WILLOWTREE PLANNING

RE: RESPONSE TO SUBMISSIONS - PROPOSED SECTION 4.55(1A) MODIFICATION APPLICATION - SSD 9522 (MOD 2)

PROPERTY AT 657-769 MAMRE ROAD, KEMPS CREEK LOT 34 DP1118173, LOTS X & Y DP421633, LOT 1 DP 1018318 & LOT 22 DP258414)

Summary of, and response to comments	
Comments	Response
Penrith City Council Comments	
1. Planning Considerations	
<p>(a) <u>Background</u></p> <p>On December 2020, development consent was granted for the development of the Kemps Creek Warehouse, Logistics and Industrial Facilities Hub (SSD-9522). The approval included the following:</p> <ul style="list-style-type: none"> – Construction of eight warehouses with a total Gross Floor Area of 162,355sqm over eight lots, – Associated loading docks, hardstands, car and truck parking, and landscaping, – Site wide bulk earthworks to create building pads, three estate basins, – Internal road network including a north-south distributor road connecting the southern neighbouring property, – Subdivision. <p>The development included the widening of Mamre Road and upgrades to an existing signalised 'T' intersection at Mamre Road and Bakers Lane to facilitate site access over two sequences (Sequence 1A and 1B)

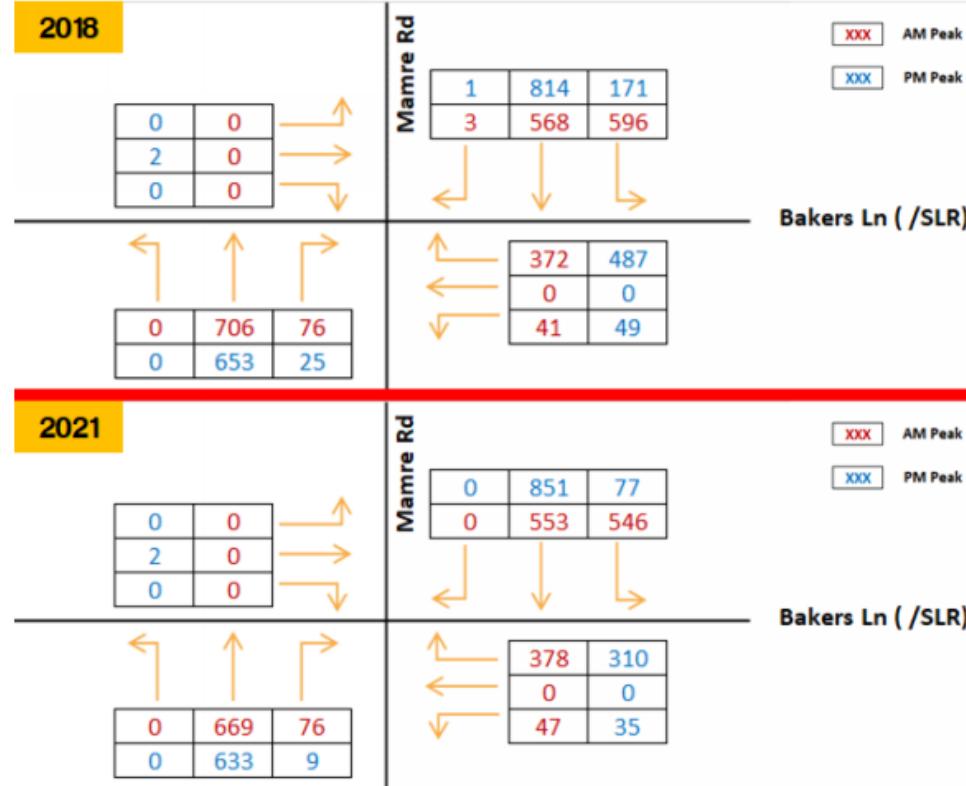
<p>The TIA states that at the request of DPIE modelling has been undertaken for the approved Modified Sequence 1A for the years of 2026, 2031 and 2036. Whilst TfNSW appreciates the modelling applied to date, it is unclear what growth rate was applied to the future year models.</p> <p>It is recommended that further clarification is provided as to what growth rates were applied for the years of 2026, 2031 and 2036.</p>	<p>The following background growth rates have been adopted for the purpose of the future year models:</p> <ul style="list-style-type: none"> 2% per annum on Mamre Road; and 1% per annum on Bakers Lane (and Southern Link Road (SLR) in latter access Sequences). <p>The traffic profiles for the above growth rates have been within figures 5 - 7 of the submitted Technical Note by Ason Group (P1780r01v7 TN_Kemps Creek SSD-9522 MOD 2).</p>

Summary of, and response to comments	
Comments	Response
	<p>The adopted growth rate is consistent with what has been done previously within the approved SSD-9522 Ason Group TA and the approved SSD-9522-MOD 1 Ason Group Traffic Impact Assessment.</p>
<p>The TIA provides some modelling summary tables however it is unclear from these summaries what the model inputs are. There is no SIDRA movement summaries which provide summarised information in reviewing models. However TfNSW were provided the SIDRA (sid.) files and outputs based on the TIA dated 6 September 2021.</p>	<p>After the meeting with TfNSW held on 14 October 2021, Ason Group provided TfNSW with the SIDRA modelling results (as a zipped file) for the years 2025, 2026, 2031 and 2036 for Sequence 1A.</p> <p>(A copy of the modelling outputs is again provided in Attachment A following changes to model labels, per separate comments below).</p>
